SERVICE BULLETIN

M-1117

Safety Recall Code 0104

2001 DYNA GLIDE FUEL HOSE CLAMP

Figure 1. Fuel Hose And Clamp

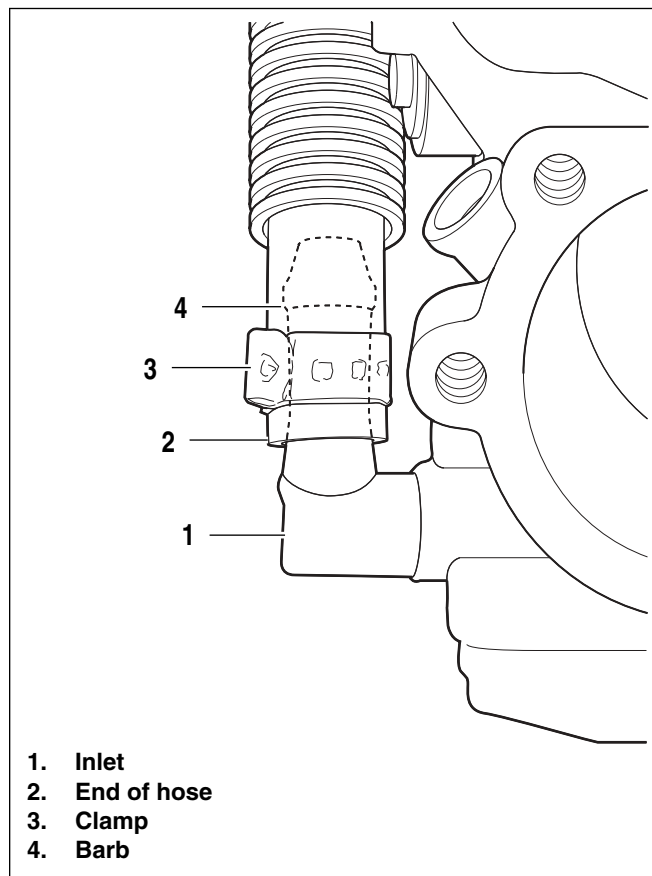
Harley-Davidson has learned a condition may exist on certain 2001 models that can cause the fuel hose to become disengaged from the carburetor inlet. This condition may cause fuel to spill and burn in the presence of an ignition source which could result in an accident or death or serious injury.

1. Remove air cleaner cover and backing plate according to the 2001Dyna Service Manual (Part Number 99481-01).
2. See Figure 1. Inspect fuel hose and clamp. Be sure top of clamp (3) is below barb (4). Verify that end of hose (2) extends past bottom of clamp.
3. If clamp and hose are not in proper position, cut clamp and reinstall hose with new clamp (Part Number 10014) using HOSE CLAMP PLIERS (HD-97087-65B) so hose and clamp positions resemble Figure 1.
4. Install air cleaner cover and backing plate according to the 2001Dyna Service Manual (Part Number 99481-01).
